ADDENDUM

PROJECT TITLE: Roof Rehabilitation Fire Station 7	ADD. NO: 3
TENDER NO: 2021-082702T	DATE: April 13, 2021
PAGE 1 of 2 (Including Confirmation Sheet)

Project:	2021 Roof Rehabilitation Program	Page No:	1 of 7
Facility:	Fire Station #7	Date:	April 13, 2021
Address:	41 Manchester Avenue Saint John, New Brunswick, E2M 5T2	IRC Ref. No:	NR21-002SP-23936
		Client Ref. No:

CHANGE OF SCOPE – SECTION 01 11 00 - SUMMARY OF WORK

APPENDIX “C” – STIPULATED PRICE BREAKDOWN

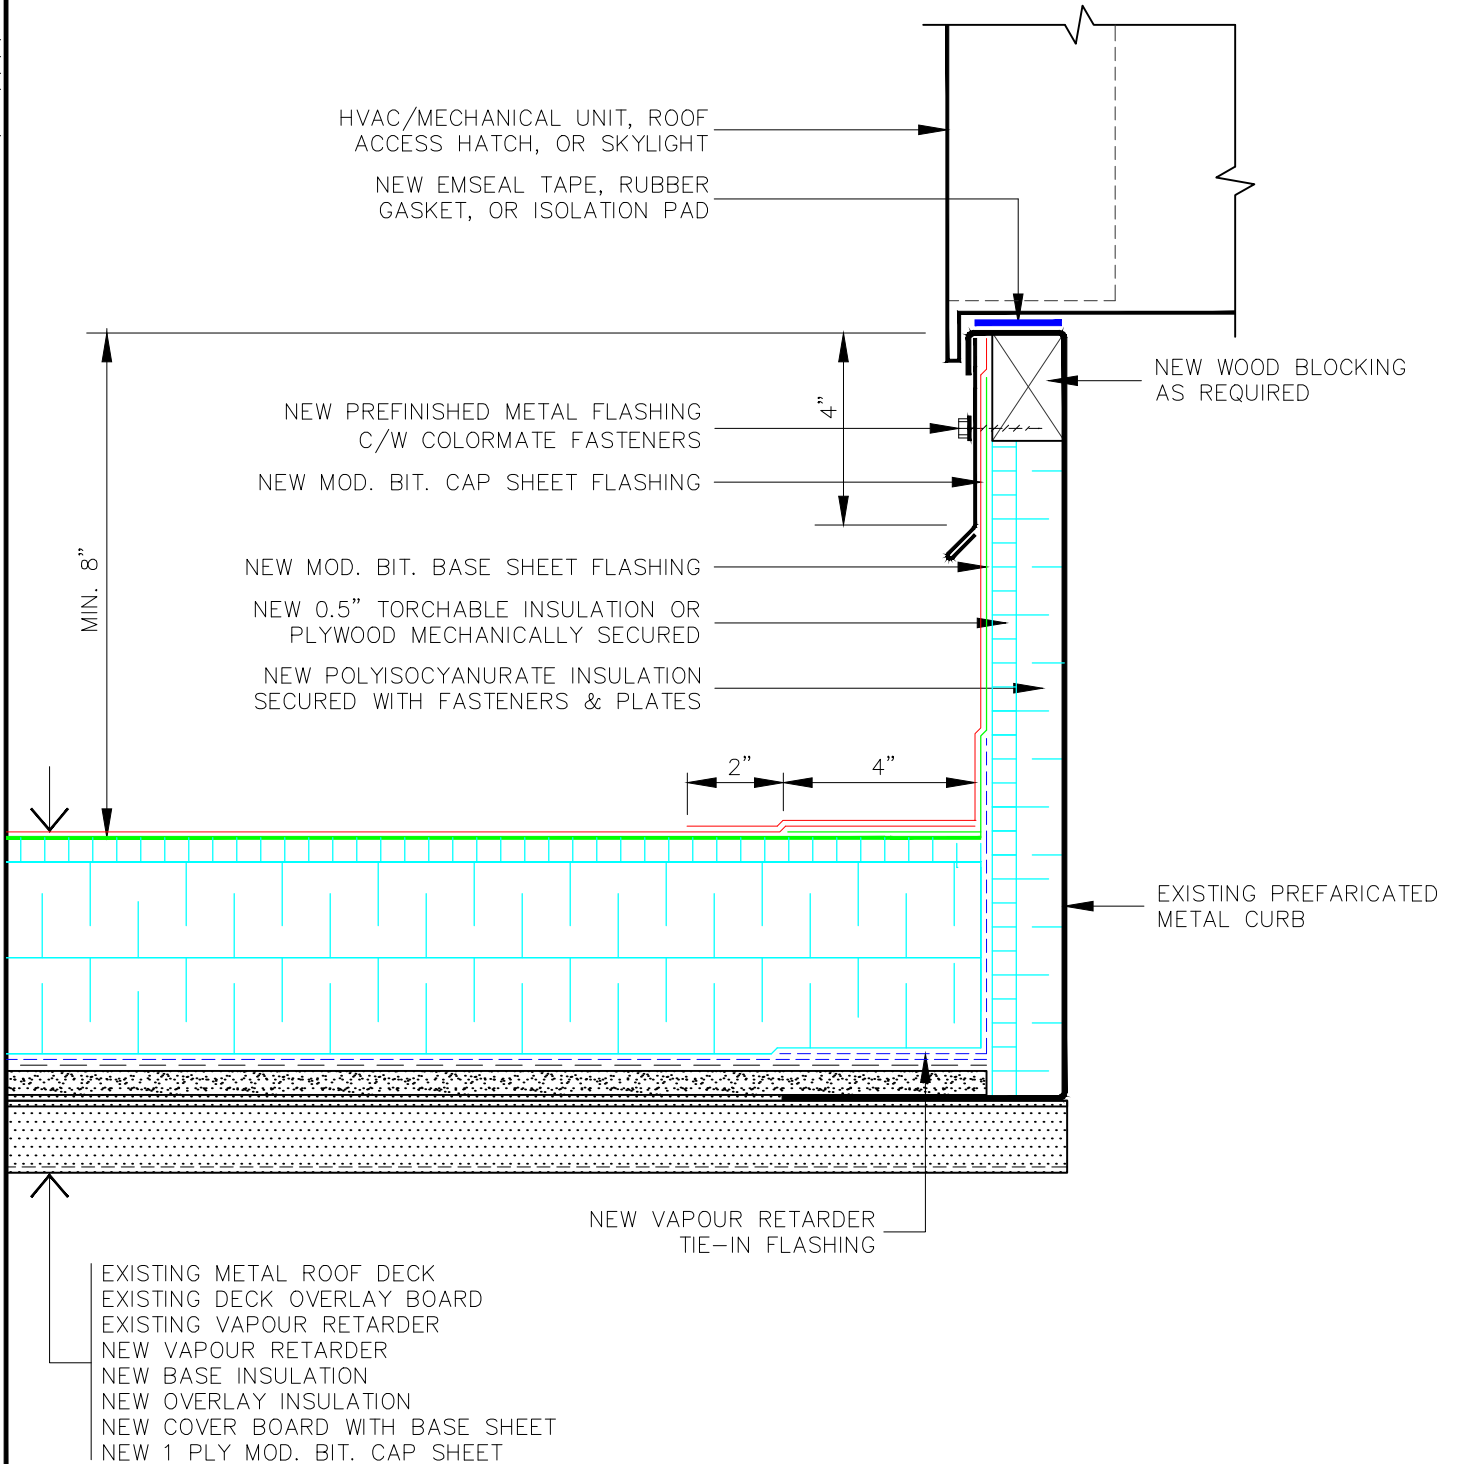
See attached new details to replace membrane retrofit details for roof section 1.1 and new "Appendix C" to replace existing.

Item No.	Description of Work	Estimated Quantity	Unit Rate	Contractor's Total Bid
1.0	Roof Recover – Low Slope:			
1.1	Roof Recover Work specified for Roof Areas 2.1 & 3.1:	Lump Sum	N/A	\$ _____
1.2	Roof Replacement Work specified for Roof Areas 1.1:	Lump Sum	N/A	\$ _____
2.0	Stipulated Price:			
2.1	Subtotal (Total of Itemized Bid Prices Above):		\$	_____
2.2	Harmonized Sales Tax (HST):		\$	_____
2.3	Total Stipulated Price (Item 2.1 + 2.2, Copied to Page One):		\$	_____
